**INVER GROVE HEIGHTS  
PLANNING COMMISSION AGENDA**

**3.01 BITUMINOUS ROADWAYS – CASE NO. 12-17CZA**

**APPLICATION FOR  
REISSUANCE OF CONDITIONAL USE PERMIT 07-11C FOR  
THE MINING AND PROCESSING OF SAND AND GRAVEL,  
AN ASPHALT PLANT AND CONTRACTOR'S YARD WITH  
OPEN STORAGE AND FIVE YEAR SAND AND GRAVEL  
OVERLAY DISTRICT**

**Figure 1**  
**SITE LAYOUT**  
 Evaluation of Proposed Pumping  
 at Bituminous Roadways, Inc.  
 City of Inver Grove Heights, MN

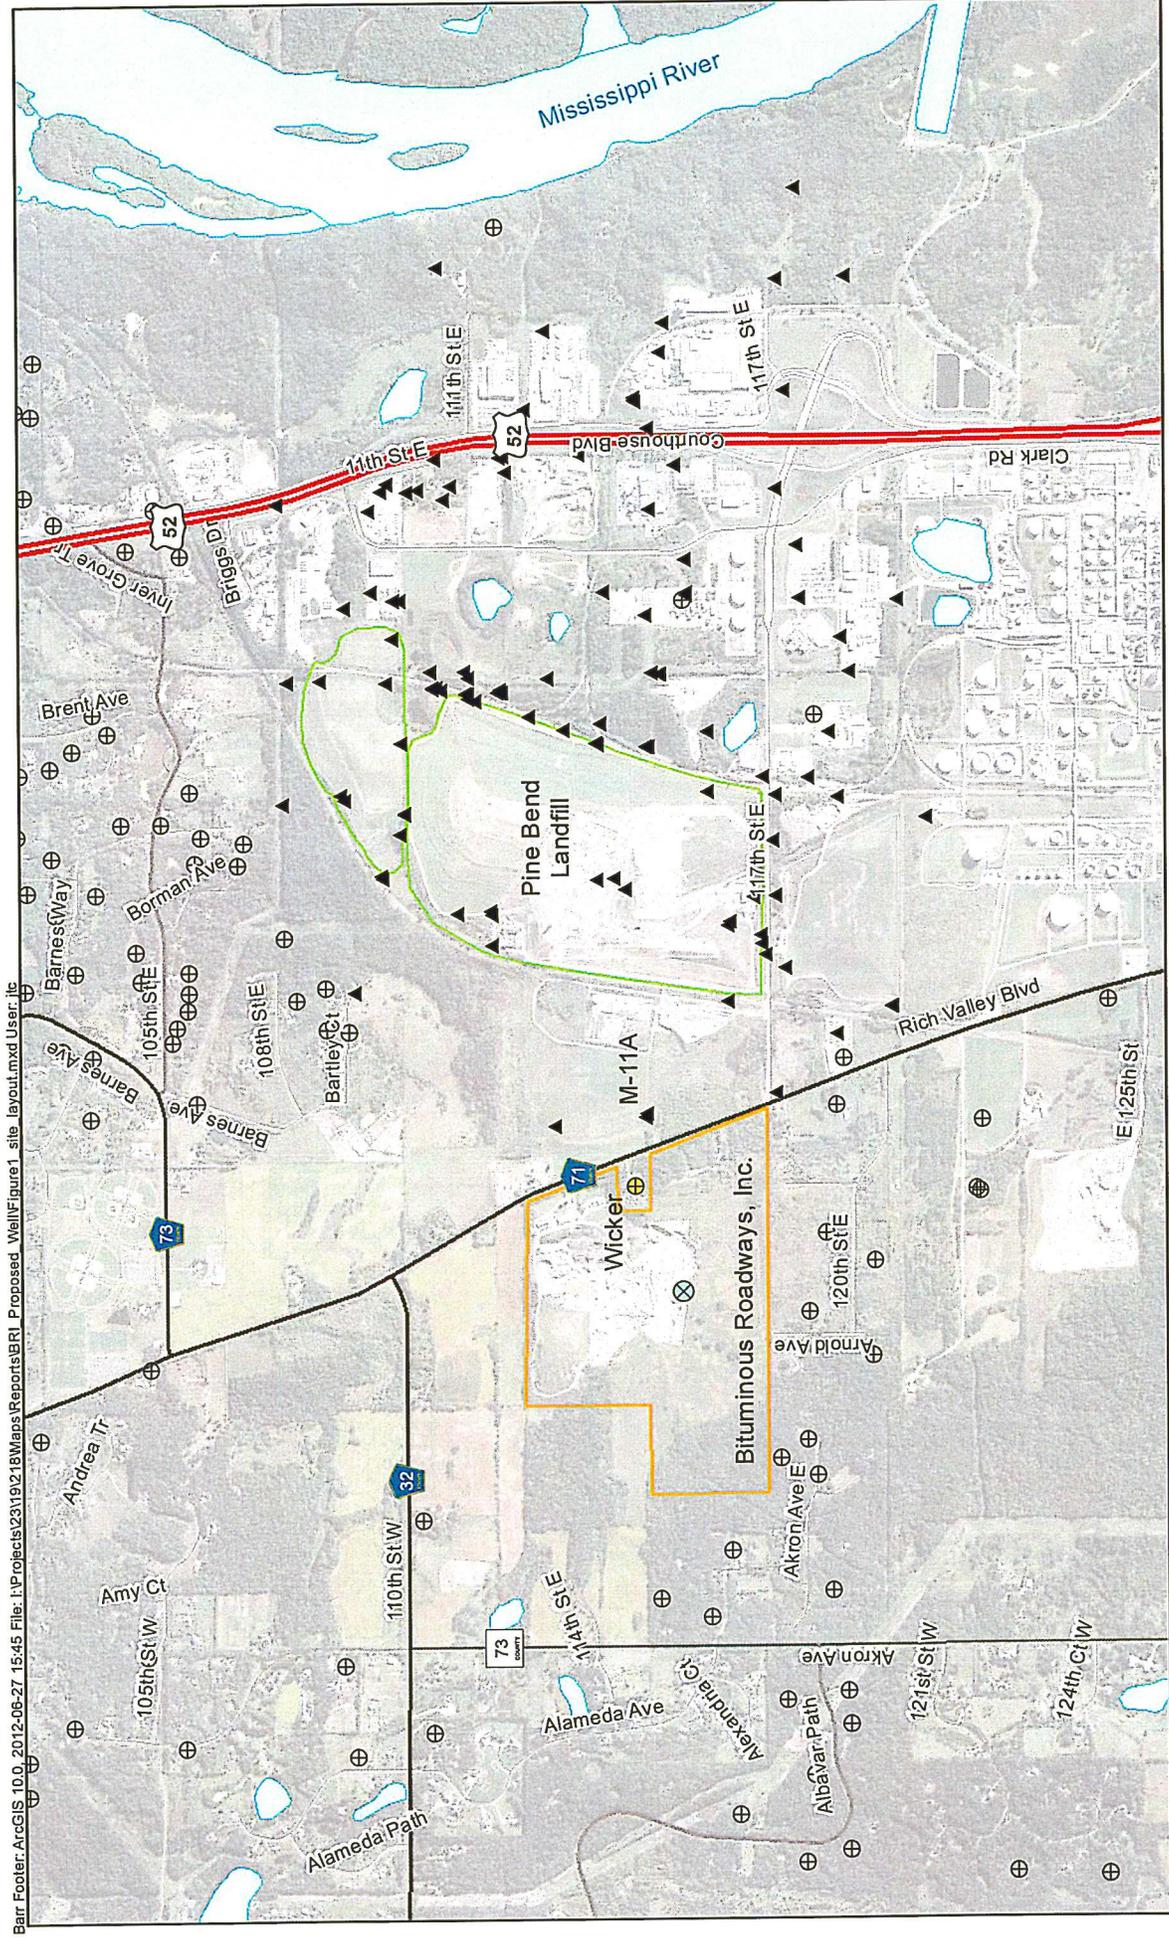
The residential and monitoring wells nearest to the proposed BRI well are shown on Figure 1. The nearest residential well is identified in the April 25, 2012 letter from Sunde Engineering as being owned by Todd Wicker. The driller's log for this well (Unique ID 435227; Appendix A) indicates that it is completed in the Quaternary sand and gravel aquifer and had 57 feet of water above the pump intake when the static water level was measured at the time of construction in 1987. The nearest PBL monitoring well is M-11A, which is also completed in the sand and gravel aquifer and is approximately 1900 feet from the proposed BRI well. In 2011, the water level in M-11A was reported to be 8 - 10 feet above the bottom of the well screen (2011 PBL Annual Report).

**Figure 2**  
**SIMULATED WATER-TABLE DRAWDOWN:**  
**POND-FILLING PUMPING SCENARIO (450 GPM)**  
 Evaluation of Proposed Pumping  
 at Bituminous Roadways, Inc.  
 City of Inver Grove Heights, MN

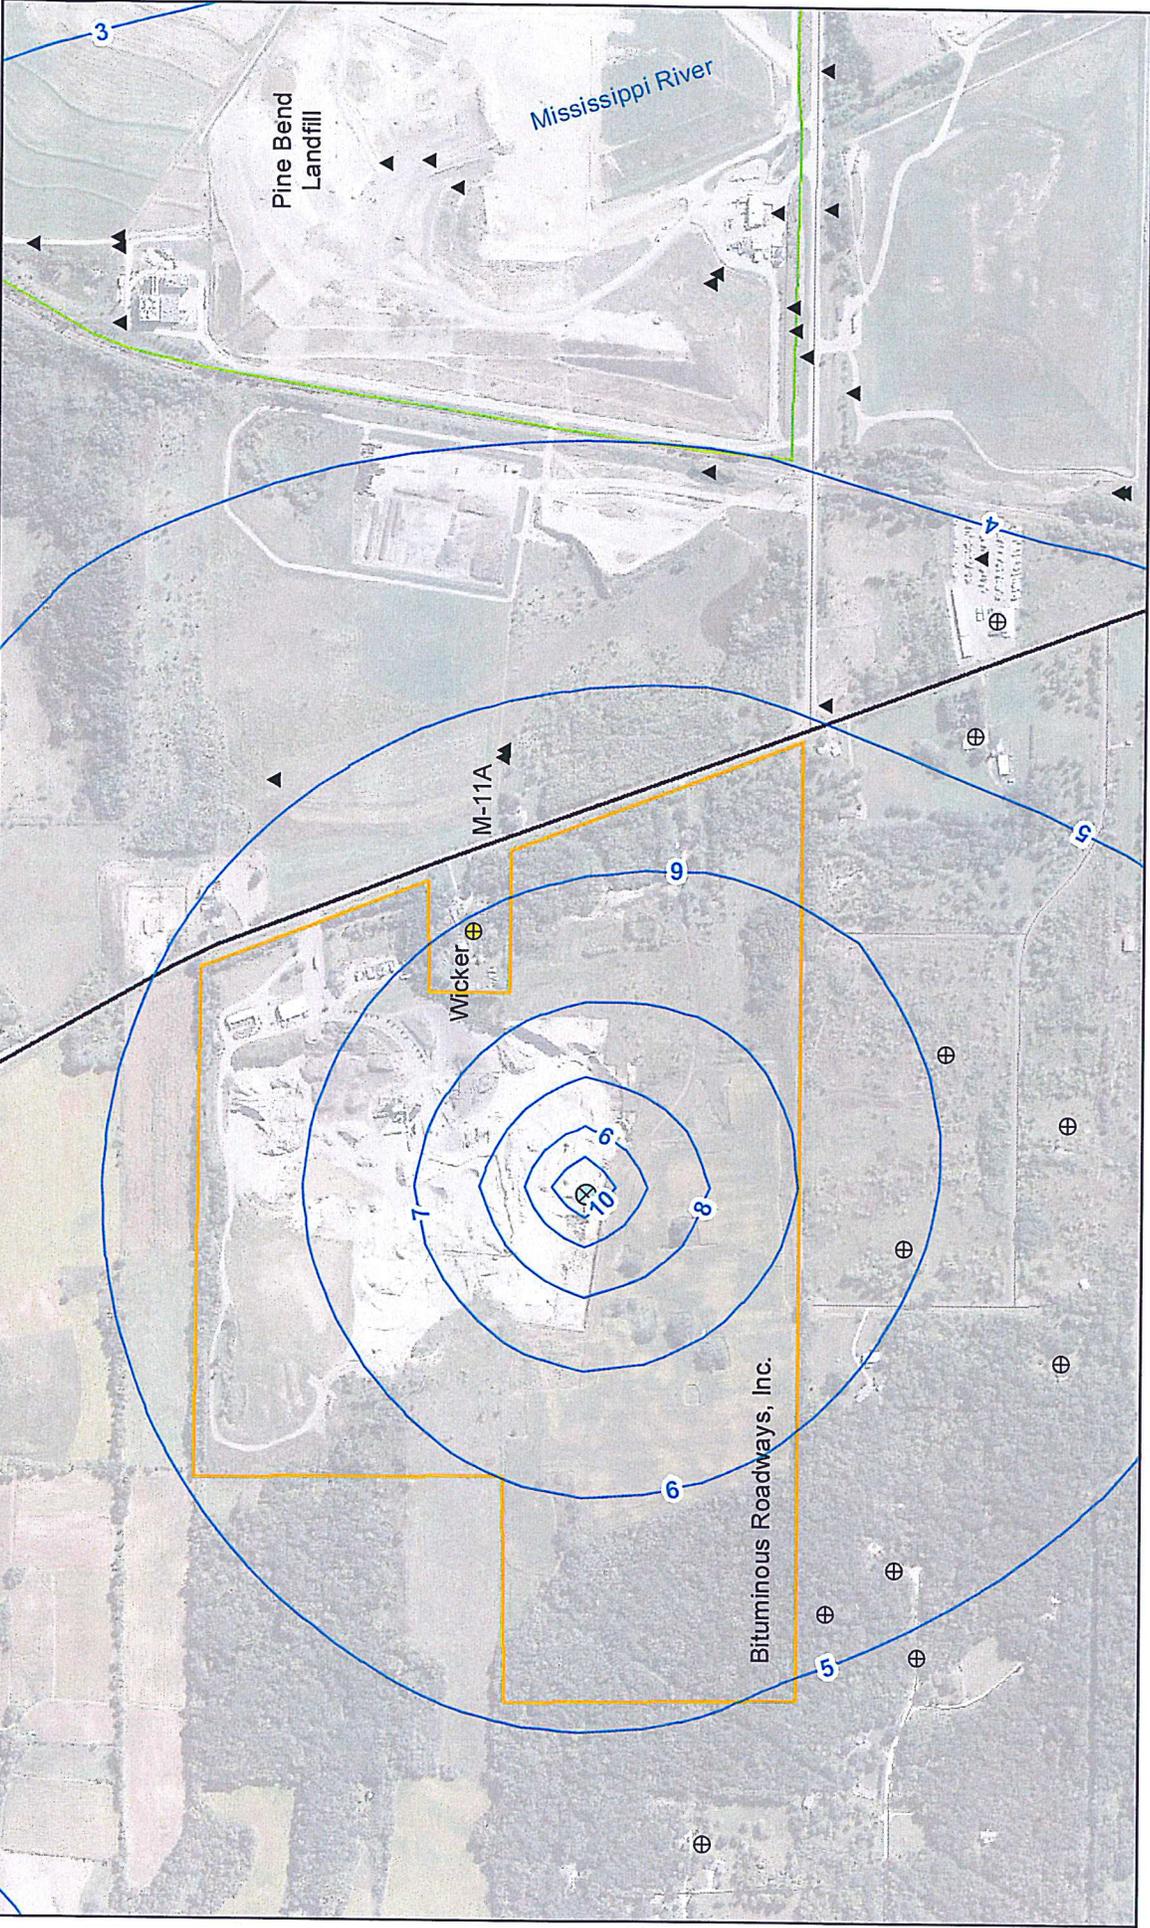
Pumping at 450 gpm for the 2-3 days required to fill the wash water ponds results in a maximum predicted lowering of the water table of approximately 11 feet at the proposed well, as shown on Figure 2. Water table drawdown of 5-6 feet is predicted in the vicinity of the Wicker residential well and landfill monitoring well M-11A. The prediction of steady-state drawdown at these wells is a conservative estimate (i.e. highest anticipated drawdown), given that the time required for drawdown effects to travel to these wells from the proposed well is not accounted for in the simulation. The predicted magnitude of drawdown is unlikely to significantly interfere with the operation of the Wicker well, but may lower the water table below the bottom of M-11A for some or all of the duration of pond filling. Should M-11A go dry, it will likely remain so for only a short period of time, as the water table will rise when the pumping rate decreases after the ponds have been filled.

**Figure 3**  
**SIMULATED WATER-TABLE DRAWDOWN:**  
**LONG-TERM PUMPING SCENARIO (160 GPM)**  
 Evaluation of Proposed Pumping  
 at Bituminous Roadways, Inc.  
 City of Inver Grove Heights, MN

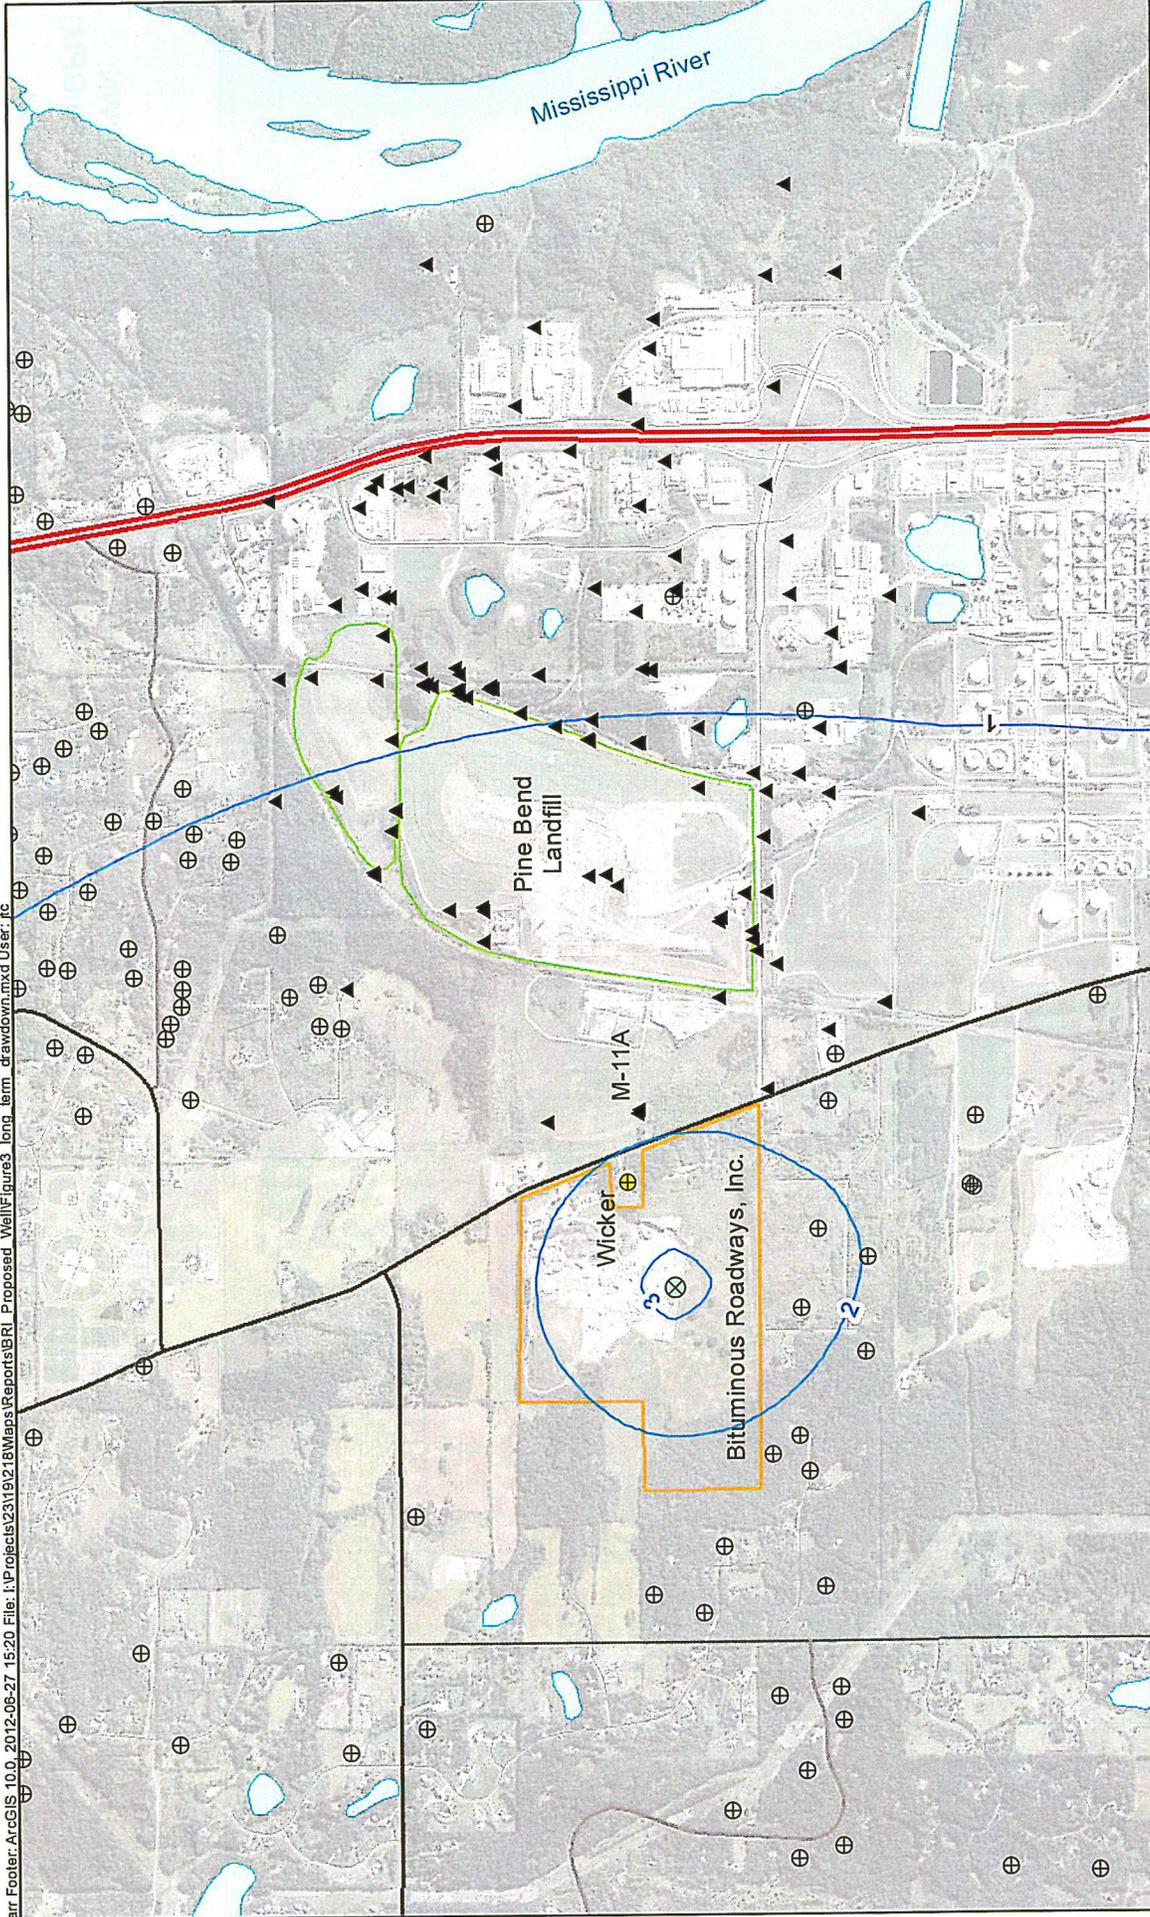
Pumping averaged over the mining season is estimated to lower the water table up to 1.5 feet in the vicinity of the PBL, as shown on Figure 3. This estimate is conservative (i.e. shows the largest anticipated impact) because it does not account for recovery during periods when the well is not being pumped. It is unlikely that this magnitude of drawdown will significantly impact the PBL monitoring wells given that the seasonal variation in water table elevation in the area likely exceeds 1.5 feet.

**Figure 4**  
**SIMULATED GROUNDWATER VELOCITIES:**  
**LONG-TERM PUMPING SCENARIO (160 GPM)**  
 Evaluation of Proposed Pumping  
 at Bituminous Roadways, Inc.  
 City of Inver Grove Heights, MN

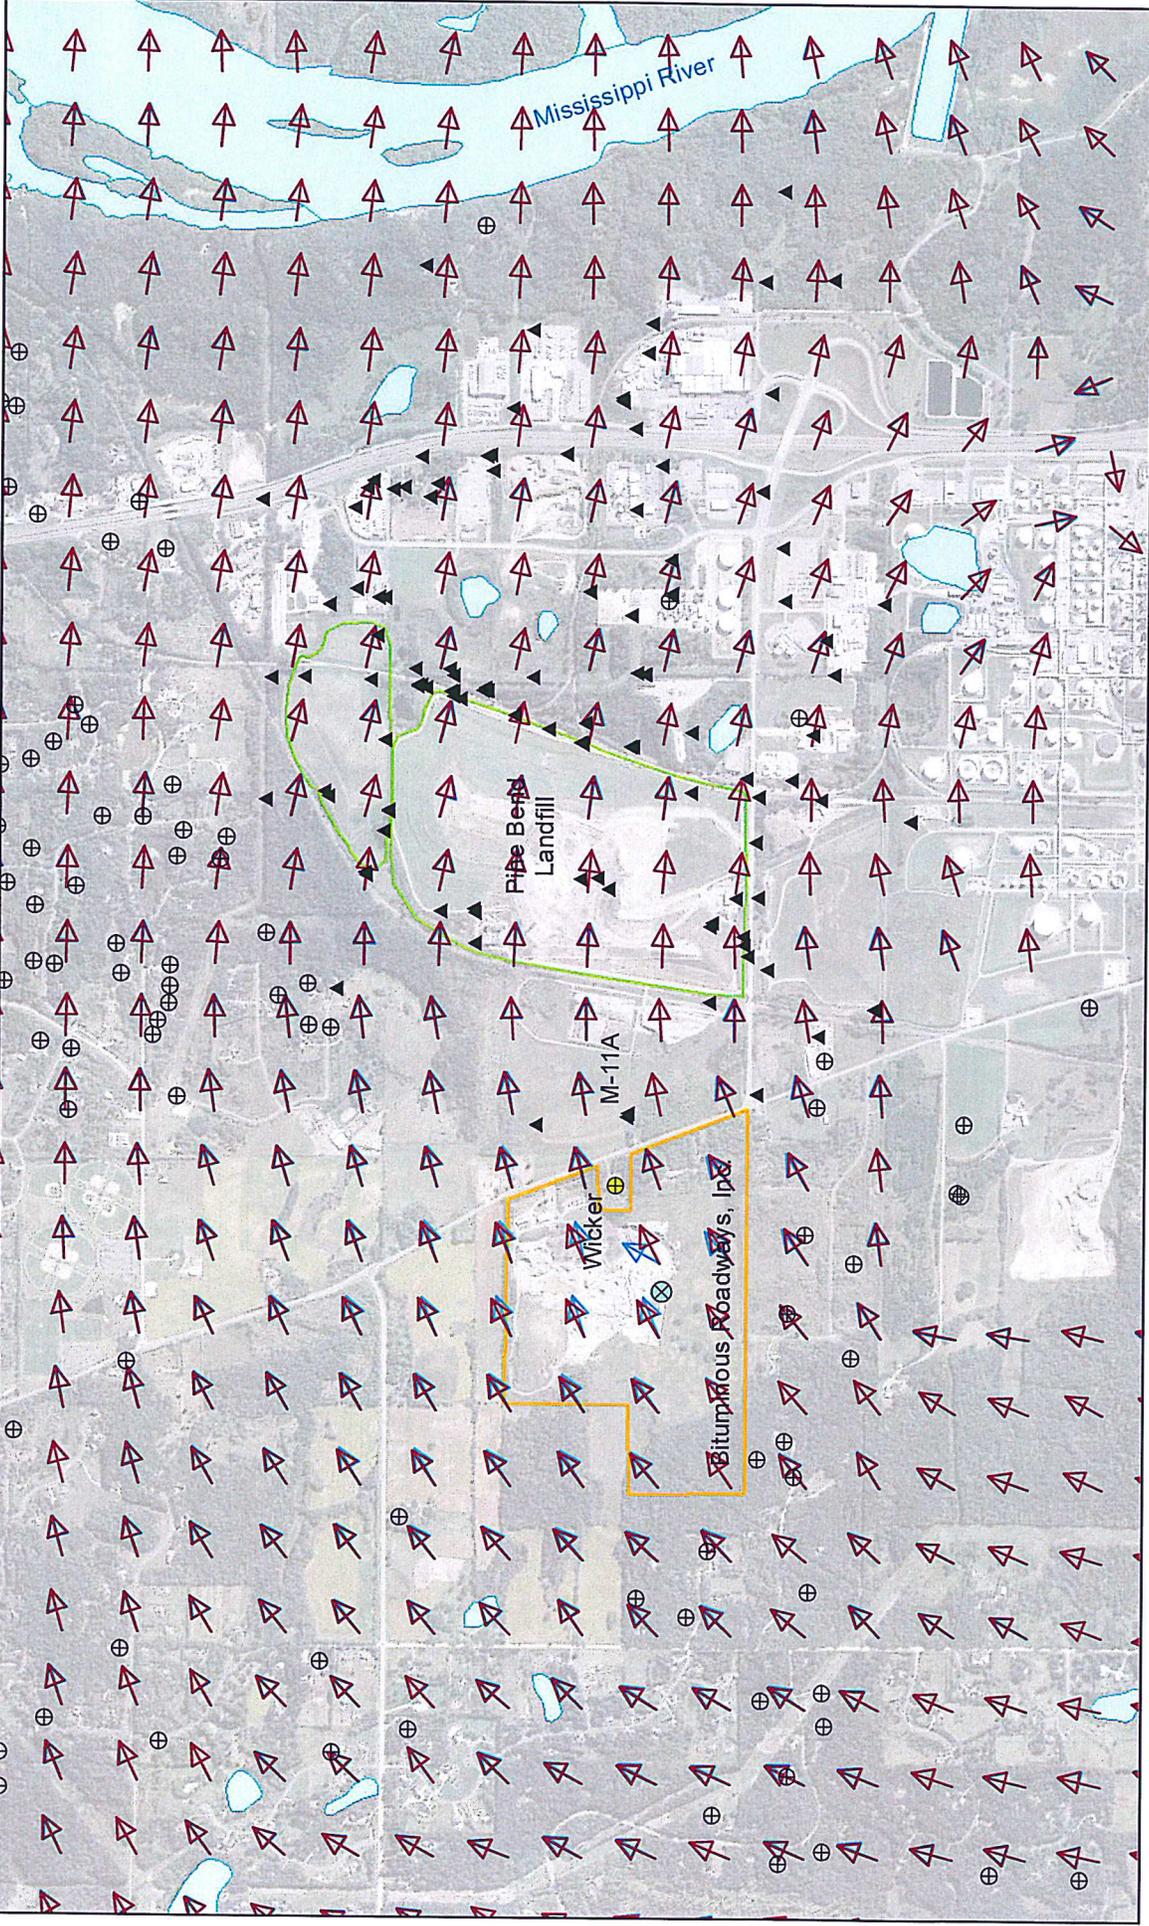
Answer: The proposed pumping is predicted to have a modest impact on the direction and velocity of shallow groundwater flow in the immediate vicinity of the proposed well and negligible impact in the vicinity of the PBL, much less than would be required to affect the direction and velocity of migration of the PBL contaminant plume. The simulated impact to groundwater flow direction and velocity is shown by the flow arrows on Figure 4, which point in

Surface water features in the area of the proposed BRI well, which are shown on Figure 1; include a number of small ponds east and west of the BRI facility and the Mississippi River to the east of the facility. The depth of the water table in the vicinity of the BRI facility – approximately 100 feet below ground surface – suggests that the ponds are poorly connected to the groundwater system and therefore are not likely to be affected by the proposed pumping. The flow arrows on Figure 4 show that the Mississippi River is a significant regional groundwater discharge area for both baseline and long-term pumping conditions. The reduction in groundwater discharge to the PBL area of the river, which is shown on Figure 4, is predicted to be less than one percent.
